1001 Queen St W – Site Plan Application – Final Report

Date:	May 23, 2008
To:	Toronto and East York Community Council
From:	Acting Director, Community Planning, Toronto and East York District
Wards:	Ward 19 – Trinity-Spadina
Reference Number:	07 238305 STE 19 SA

This application is to permit the development of three new buildings in Phase 1b of the CAMH (Centre for Addiction and Mental Health) redevelopment that will result in the transformation of the CAMH site into an “Urban Village” that is integrated into the surrounding neighbourhood.

Building B2 South Elevation

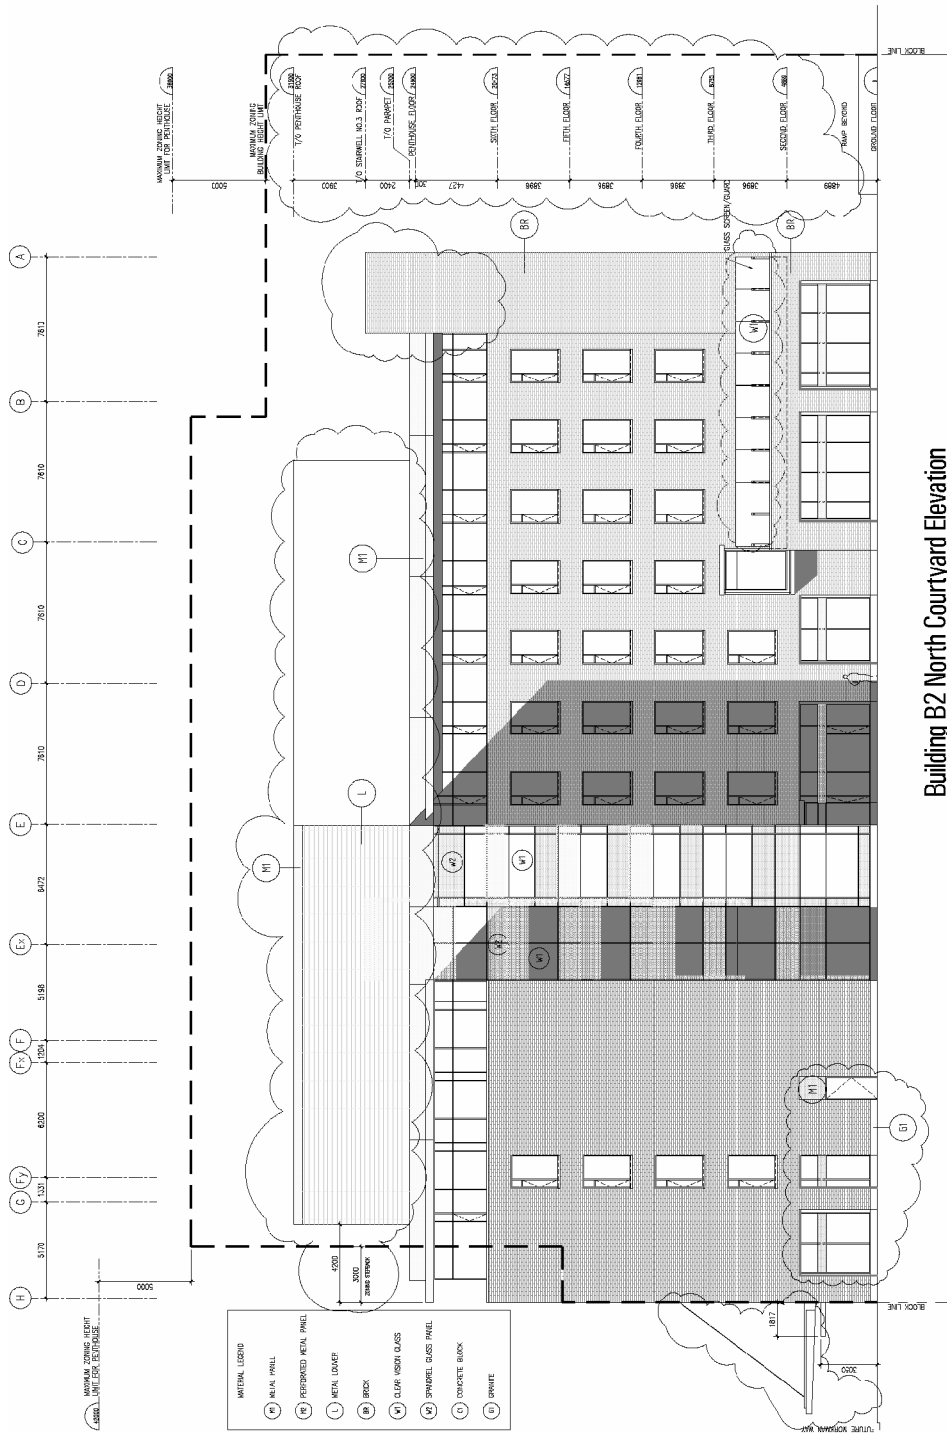
The mechanical penthouse is in a highly visible location with long views to the building from the park and other locations on the CAMH site. Staff have worked with the applicant to ensure the mechanical penthouse is integrated into the design of building as a whole as opposed to it just sitting on top of the building like a 'hat'. The applicant has attempted to reduce the bulk of the penthouse and set it further back from the edges of the roof.

Building C2 South Elevation

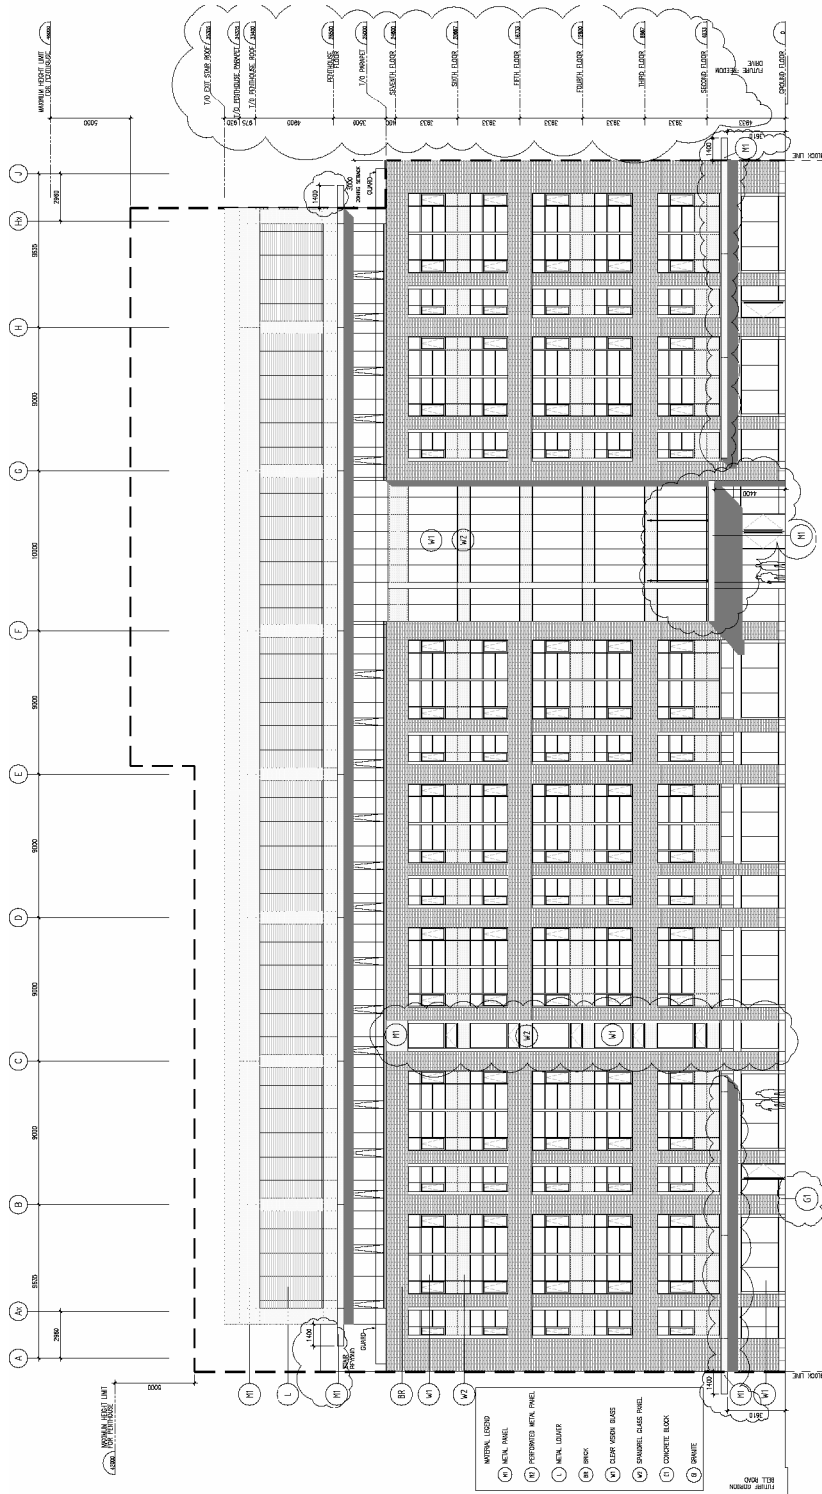
The south elevation of Building C2 is very long (77m) and is located opposite Building G1, which is another very long building. In an effort to relieve the potential of monotony of these facades, which is emphasized by the substandard width of 'New Street', and to convey the impression of a finely grained downtown neighbourhood, staff worked with the project architects to divide the façade into smaller modules. The result is that the building gives the impression of three buildings rather than one.

Building G1 North Elevation

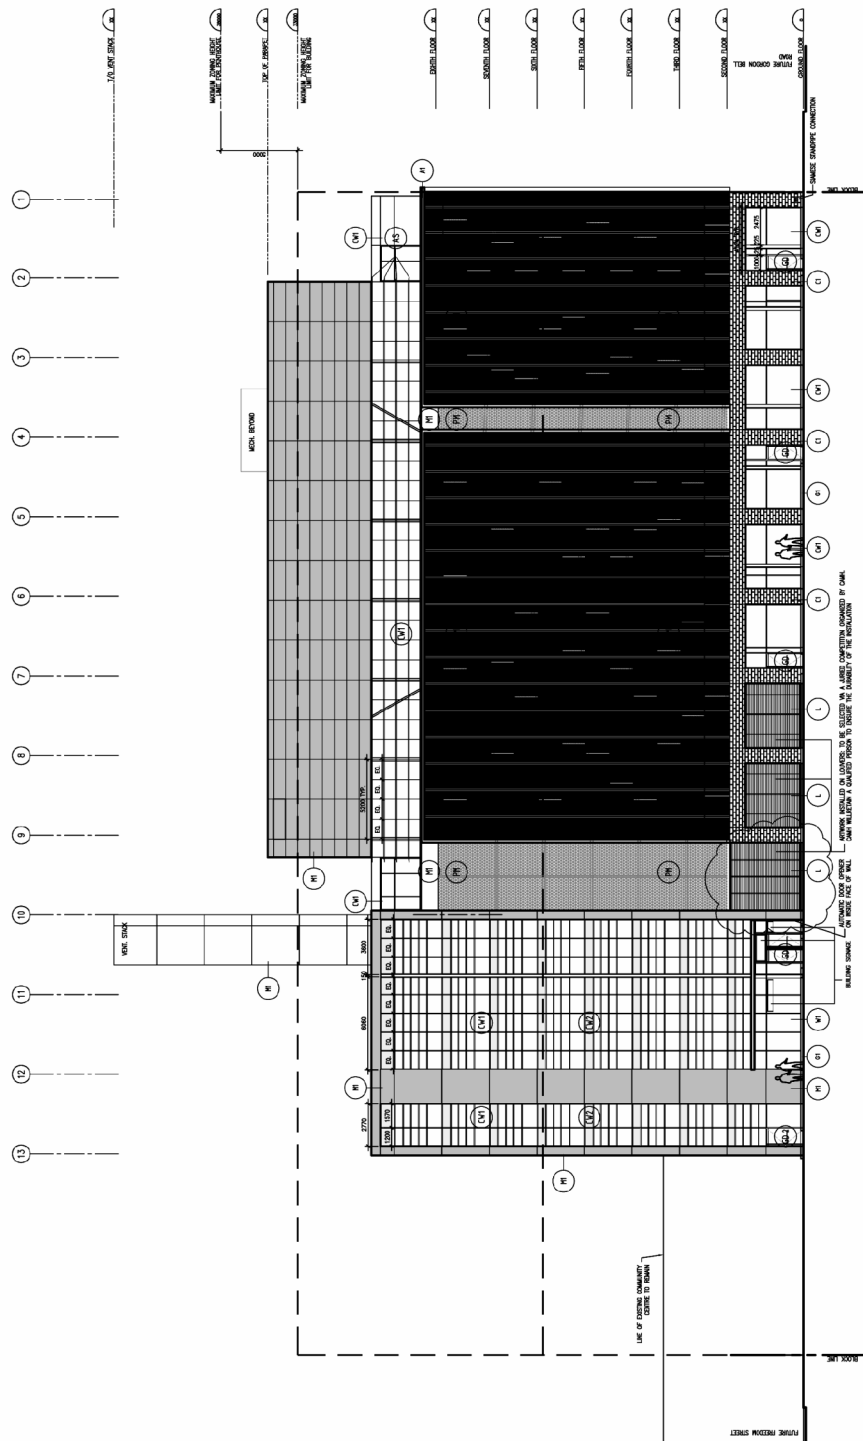
Building G1 contains 6 levels of above grade parking. Zoning By-law 893-2003 specifies that above grade parking structures should be enclosed by a fully articulated façade to provide an attractive face to the street and so that parked cars are not directly visible.

There has been much discussion between the applicant and staff to ensure the parking structure looks like a building and not an above ground parking structure. However, staff are still concerned with the appearance and design of the building, particularly the lack of colour and prevalence of grey metal cladding and other grey or black materials. These materials have the potential to detract from the creation of a comforting and welcoming environment for CAMH patients and other visitors to the site.

Staff are also concerned about the appearance of the building at the street level, next to the pedestrian sidewalk. Architectural concrete block is proposed for the façade of building at ground level, which in staff's opinion has the potential to look flat and dull. Staff would prefer to see alternative materials and a higher level of detail at the ground level.

Another concern relates to the use of metal panels on the mechanical penthouse on Building G1. Although an attempt has been made by the applicant to set the penthouse back and reduce the height, it is still in a highly visible location. Given the predominance of other grey metal cladding on this building and previous staff experience with other

buildings in the city that have metal cladding on the mechanical penthouses, staff would prefer to see an alternative material or colour used on G1's mechanical penthouse.

To address the outstanding design concerns, staff have included a pre-condition in the Notice of Approval Conditions to require CAMH to work further with staff on the design of Building G1, to the satisfaction of the Director of Community Planning, South District.
